### STAFF RECOMMENDATION 1400 Ordway Place January 17, 2018

**Application:** New construction—infill; Setback determination  
**District:** Lockeland Springs-East End Neighborhood Conservation Zoning Overlay  
**Council District:** 06  
**Map and Parcel Number:** 08309049000  
**Applicant:** Duane Cuthbertson  
**Project Lead:** Melissa Baldock, melissa.baldock@nashville.gov

| <p><b>Description of Project:</b> Application is to construct one-and-a-half story infill on a vacant lot. The infill requires a side setback determination from ten feet (10') to six feet, two inches (6'2") on the North 14<sup>th</sup> Street property line.</p> <p><b>Recommendation Summary:</b> Staff recommends approval of the project with the following conditions:</p> <ol style="list-style-type: none"><li>1. The infill's finished floor height be consistent with the finished floor heights of the adjacent historic house, to be verified by MHZC staff in the field;</li><li>2. Staff approve a brick sample;</li><li>3. Staff approve the roof shingle color and texture;</li><li>4. Staff approve the material of front porch steps and floor;</li><li>5. The front door be at least one-half glass, and staff approve the f

Figure 2 (left) shows the proposed site plan with the use easement. Figure 3 (right) shows the infill design that MHZC approved, with conditions, in February 2017.

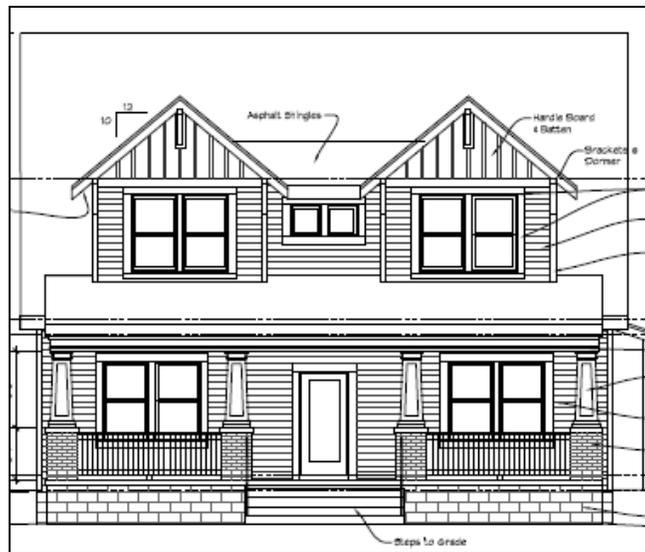
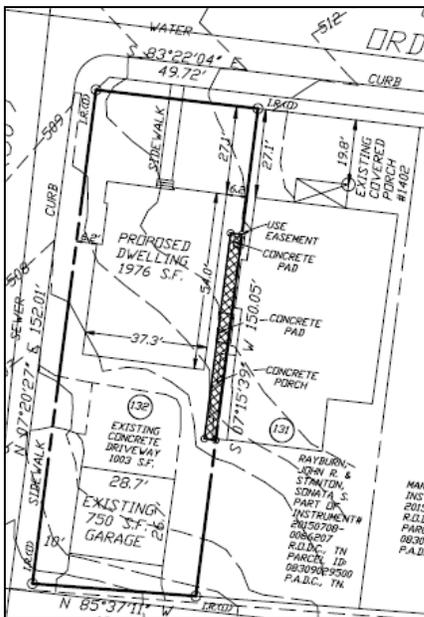
**Background:** 1400 Ordway Place is a vacant lot located at the southwest corner of North 14<sup>th</sup> Street and Ordway. Until recently, the lot was part of a double lot at 1402 Ordway Place (Figure 1). In February 2017, the applicant applied to MHZC to construct infill on the vacant portion of the lot. As part of that review and approval, MHZC determined that the existing house at 1402 Ordway Place can have a right side setback that sits on the re-established lot line. The applicant’s site plan shows that a “use easement” has been established between the properties at 1400 and 1402 Ordway Place (Figure 2).

At the February 2017 MHZC public hearing, MHZC also voted to approve the design of a one-and-a-half story house at 1400 Ordway, with several conditions (Figure 3). As part of the approval, MHZC established that the infill could have a side setback of six feet, six inches (6’6”) from the North 14<sup>th</sup> Street property line. MHZC’s approval also included the design of a Detached Accessory Dwelling Unit, with some conditions. MHZC staff never received revised drawings after the public hearing and did not issue preservation permits for the infill and DADU.

**SITE PLAN EXHIBIT**

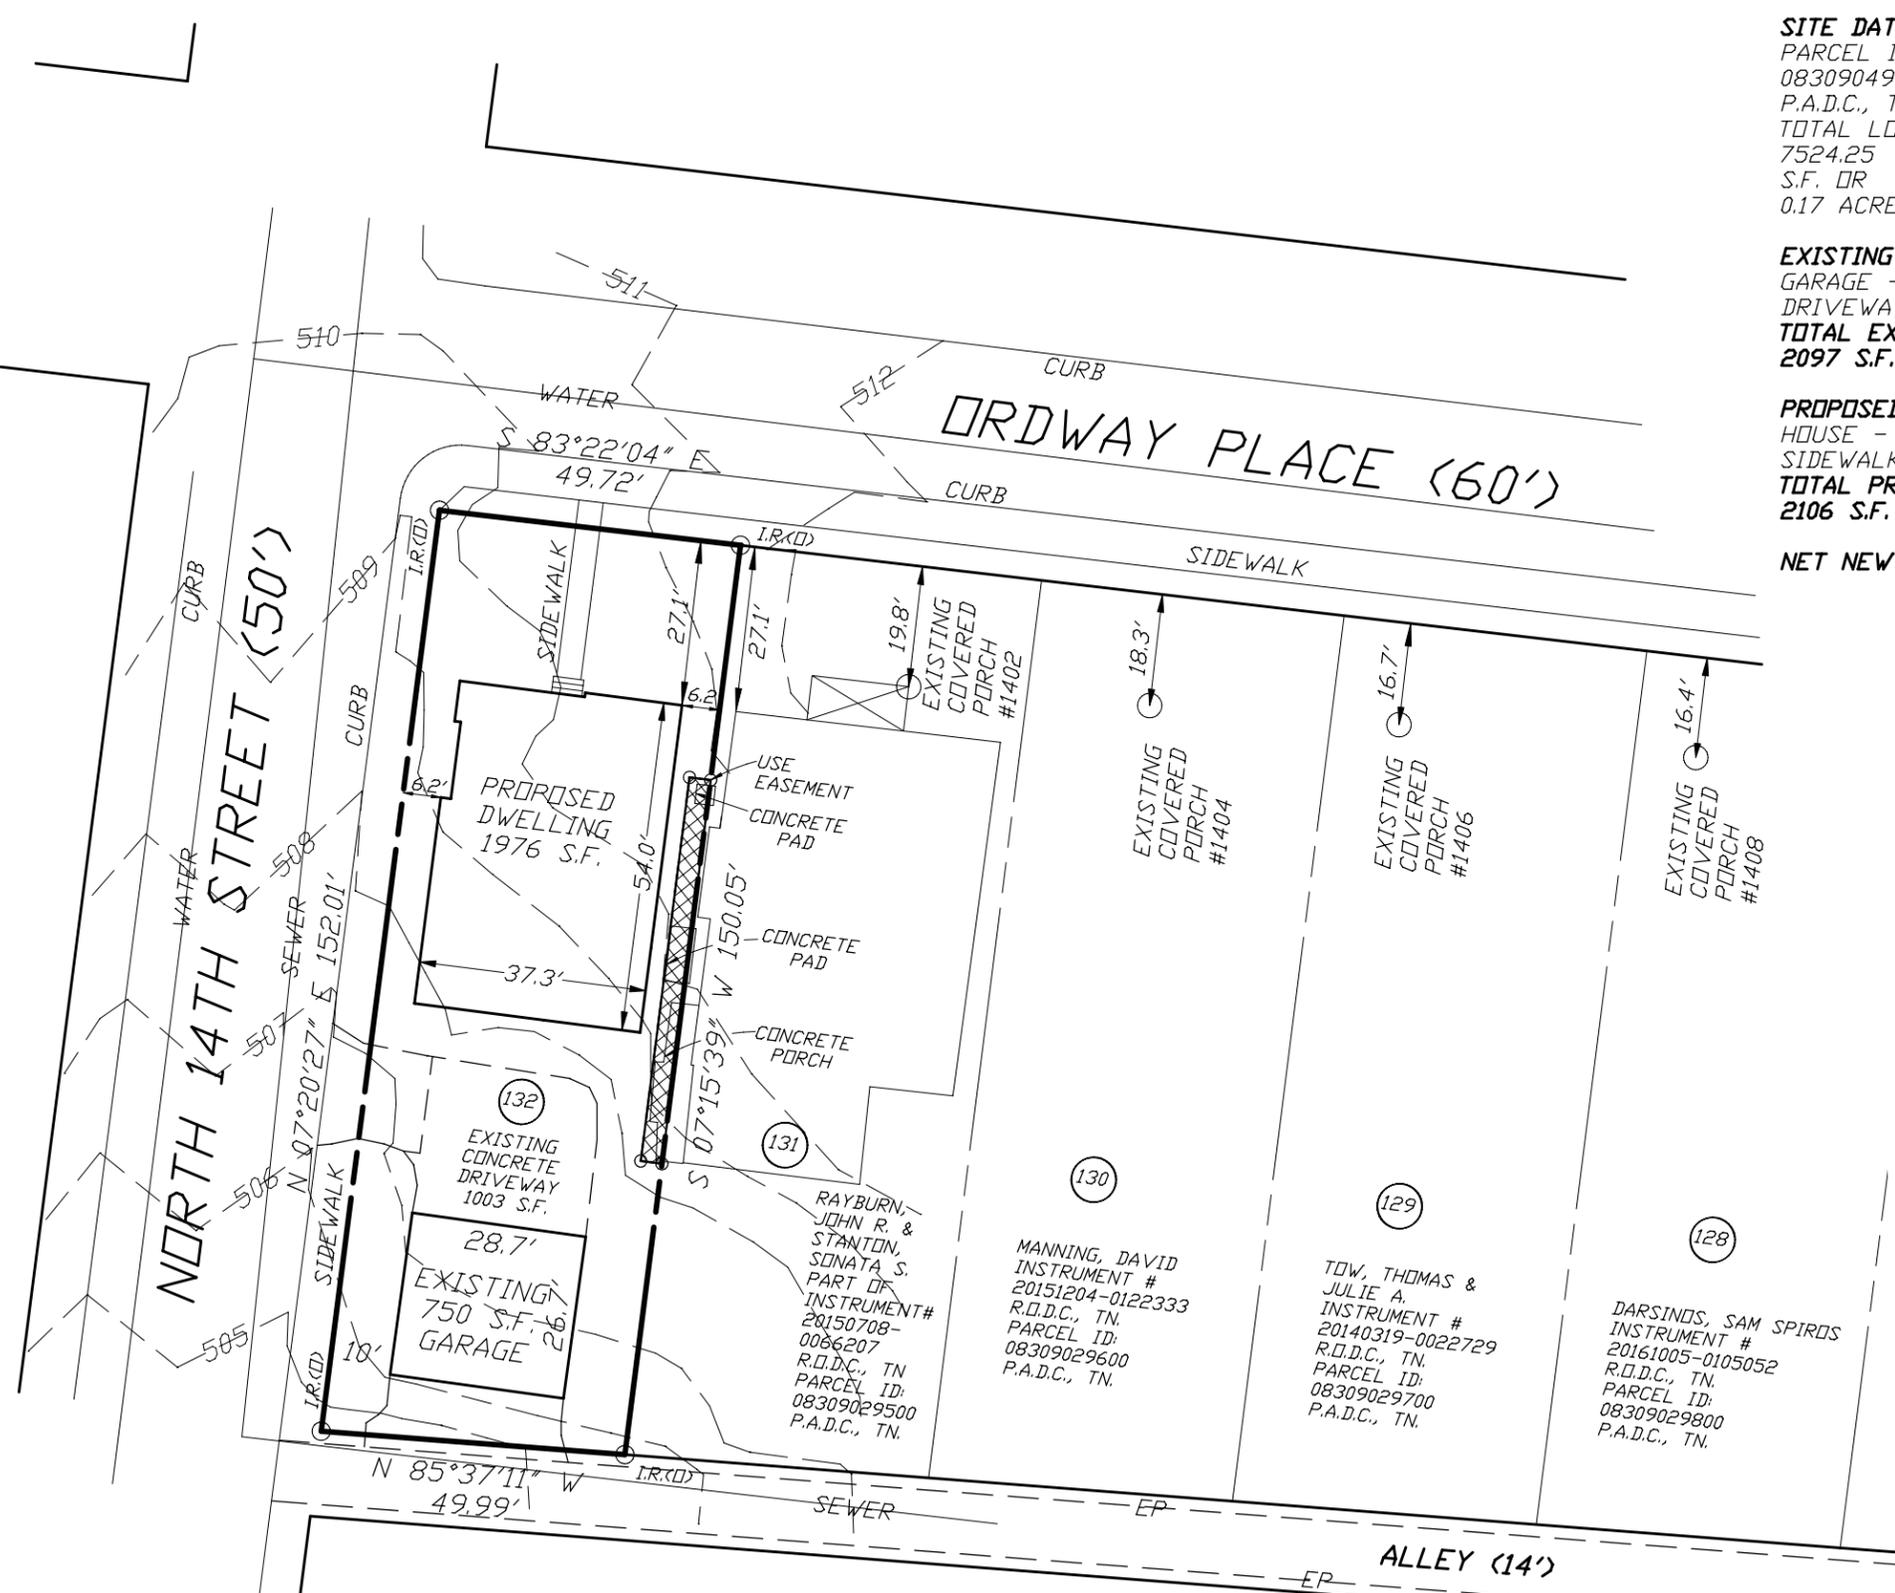
The applicant is proposing to situate the house approximately six feet, two inches (6'2") from the 14<sup>th</sup> Street side property line. Base zoning requires that houses on corner lots like this one be a minimum of ten feet (10') from the side street property line. The infill therefore requires a side setback determination. Typically, the Commission has required applicants to meet the ten foot (10') side setback on corner lots, although there have been a handful of cases where the Commission has reduced the side setback when that met the historic context. In February 2017, the Commission approved a 14<sup>th</sup> Street setback of six feet, six inches (6'6") for a similarly-sized infill on this lot.

Staff finds the six foot, two inch (6'2") setback to be appropriate for several reasons. The house needs to sit a minimum of six feet (6') from the interior-side property line in order to meet fire code for the distance between two houses, whereas base zoning would

typically allow only a five foot (5') setback. In addition, there are neighboring historic houses that have side setbacks less than ten feet (10') from their 14<sup>th</sup> Street property lines. For instance, the house across the street at 1401 Ordway has a side porch that is approximately eight feet (8') from the side property line, although the bulk of the house does meet the ten foot (10') side setback (Figure 4). 1401 Gartland, which is across the alley behind 1400 Ordway, has a 14<sup>th</sup> Street setback of between five feet, ten inches (5'10") and six feet, three inches (6'3") (Figure 5). Because of the historic context, staff finds that the 14<sup>th</sup> Street setback of six foot, two inches (6'2") is appropriate.

With the condition that the front wall of the infill be pushed back to line up with the front wall of the historic house, staff finds that the proposed setbacks meet Section II.B.3. of the design guidelines.
